Service Info

Coolant pump housing has been modified

Engines: 1.8 TDCI

Part no.: 538 0256 10

Fig. 2: Modified mounting points of the coolant pump

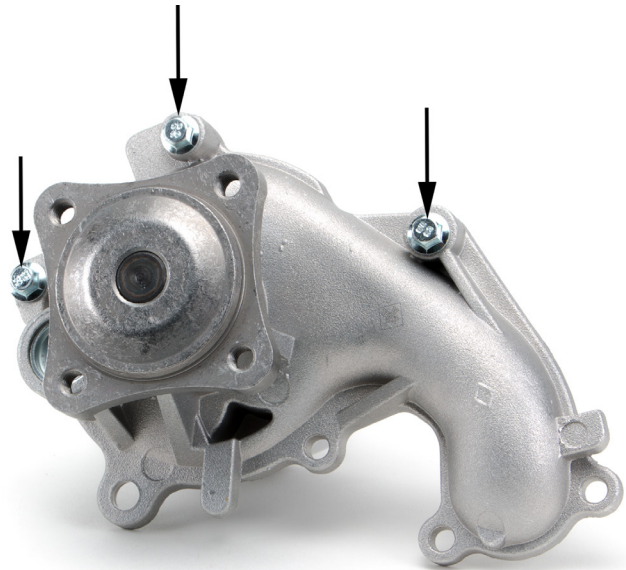
The housing of coolant pump 538 0256 10 has been modified. As a result, the screws (M6x37) supplied with the pump absolutely must be used at the three mounting points indicated (Fig. 2).

The increased material thickness at the three mounting points necessitates the use of these longer screws.

Use supplied screws
